PRELIMINARY/ FINAL DRAINAGE REPORT FOR RIVERBEND CROSSING FILINGS NO. 1 AND 2

SEPTEMBER 2018

PCD FILE NOS:
SP 187
SF 1843
SF 1844

Figure 7-7. Street Capacity Charts Residential (Detached Sidewalk)

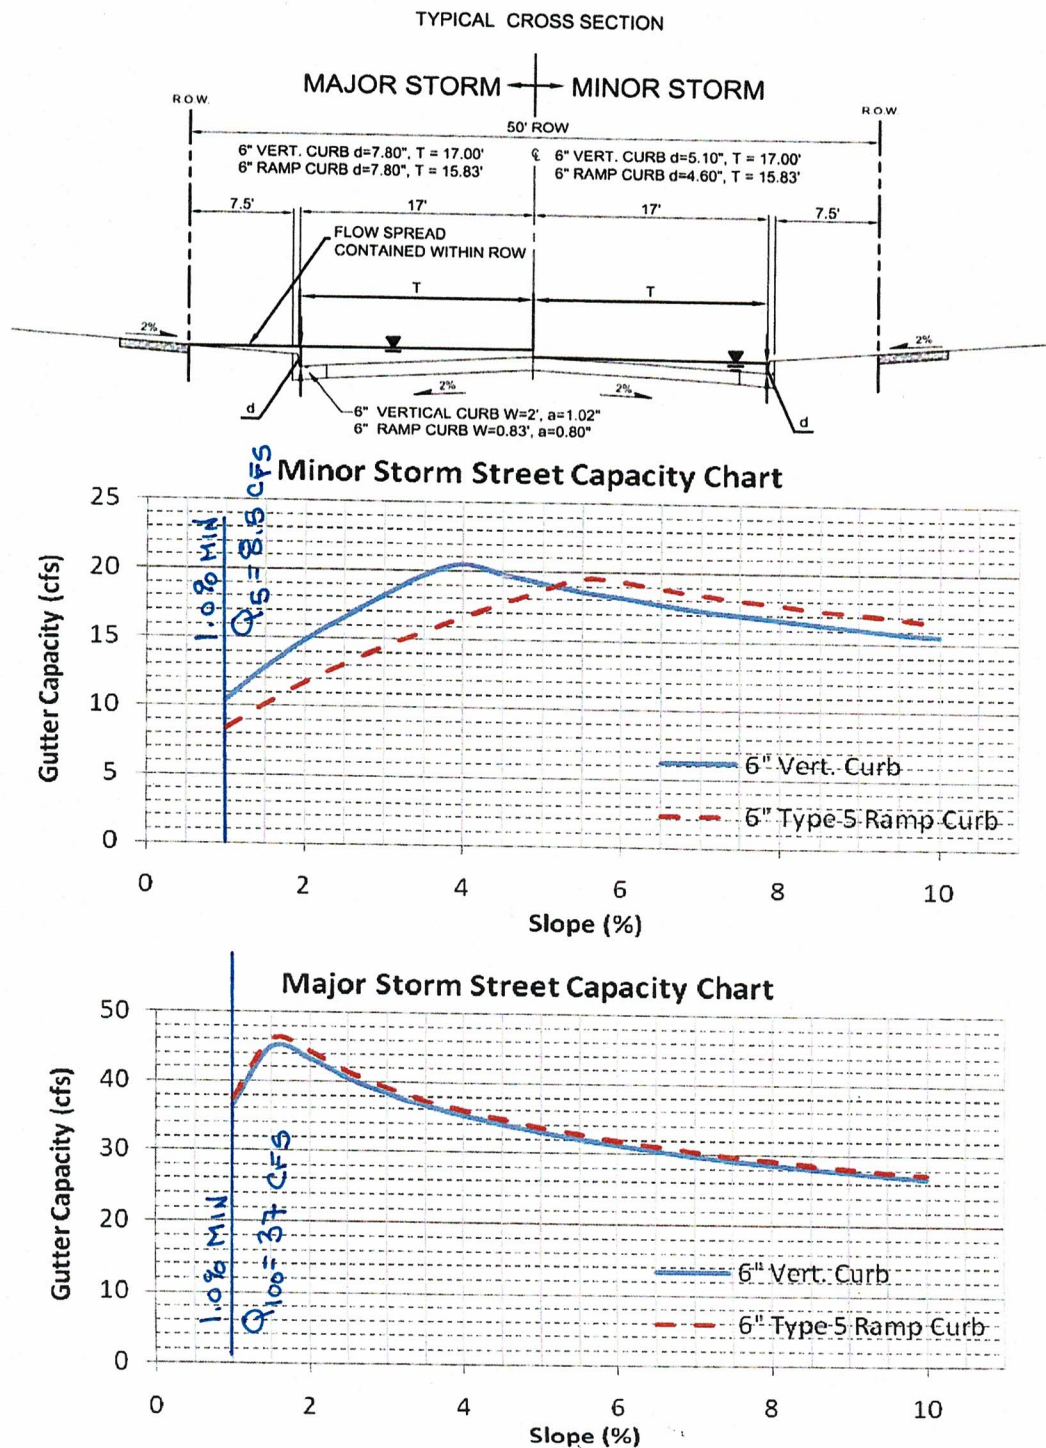
For local road this is mainly back of sidewalk. Revise the manning's n. Unresolved

14" gutter for Optional Type C curb Unresolved

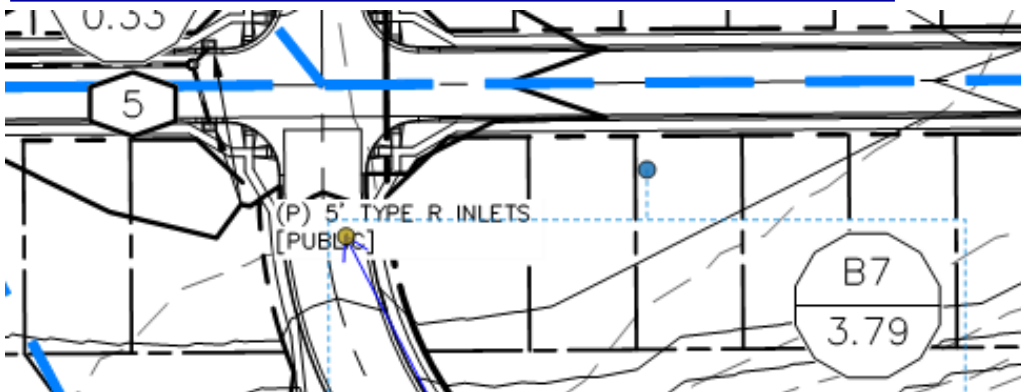
The inlet calculation for basin B7 indicates a 10' inlet. Revise the drainage map.
Unresolved. Check all the other inlets for consistency.

FIGURE A4 – Drainage Patterns as Depicted in the DBPS

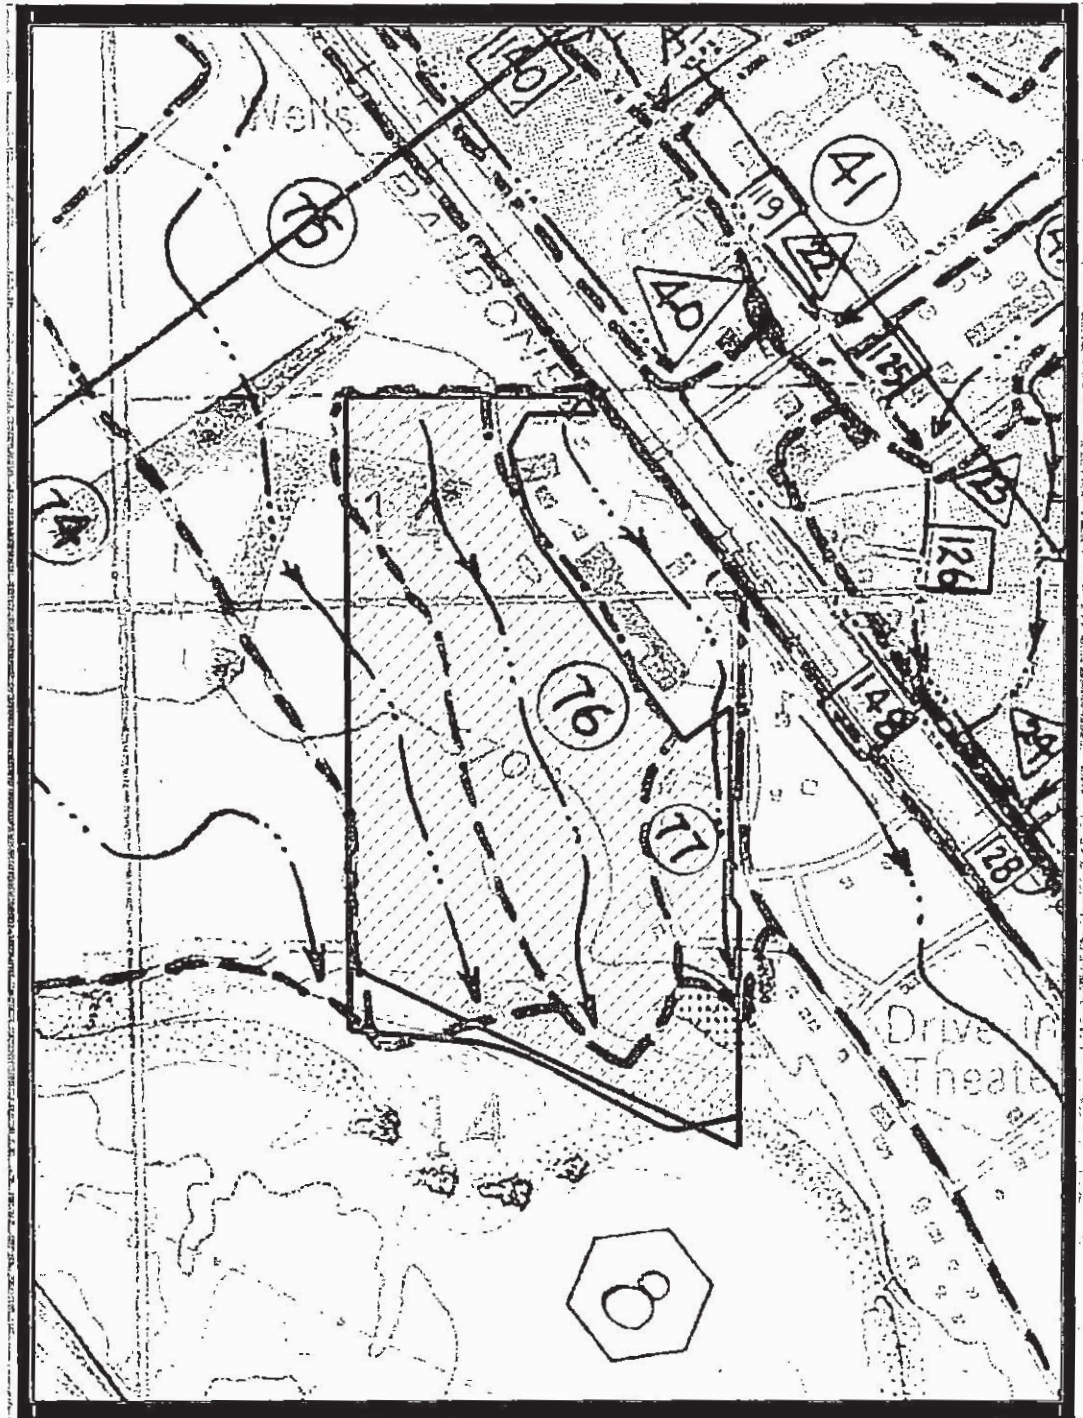
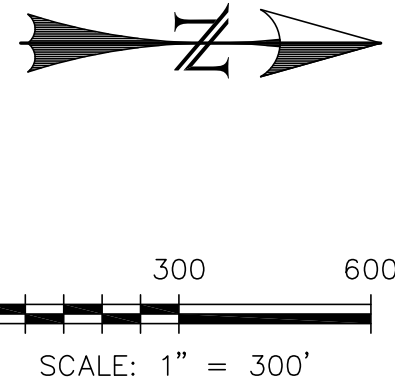
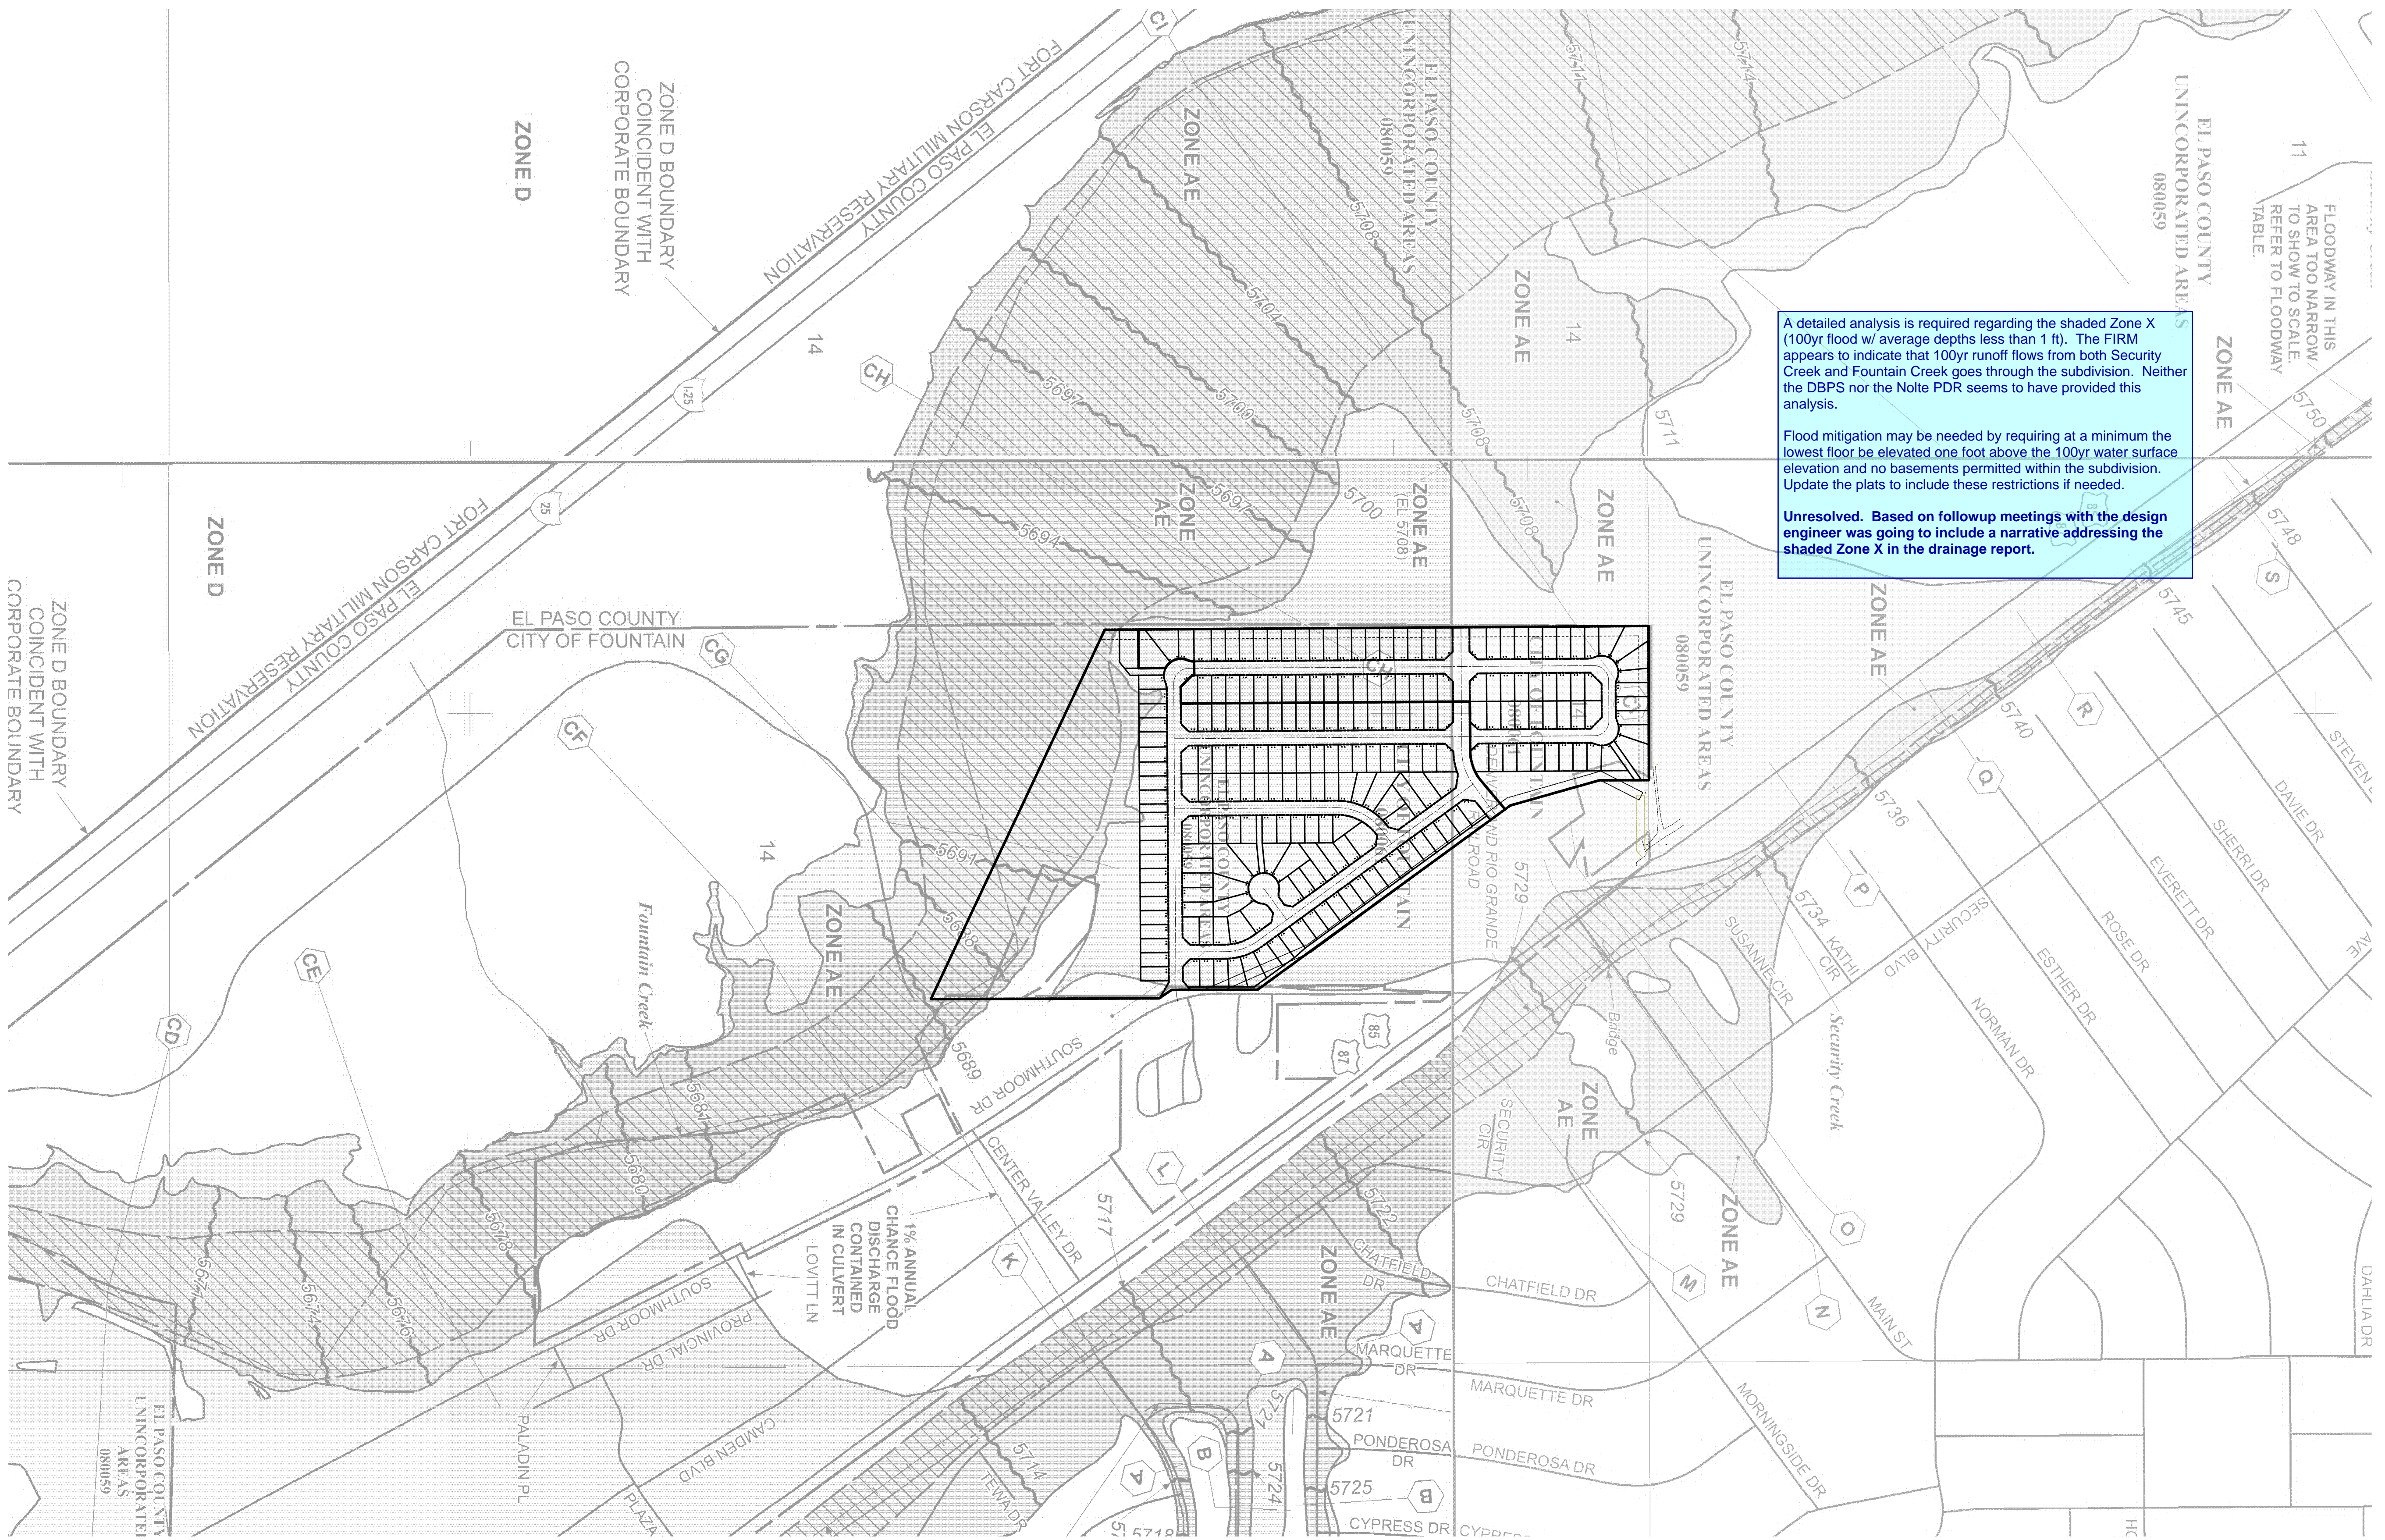
Add a north arrow.
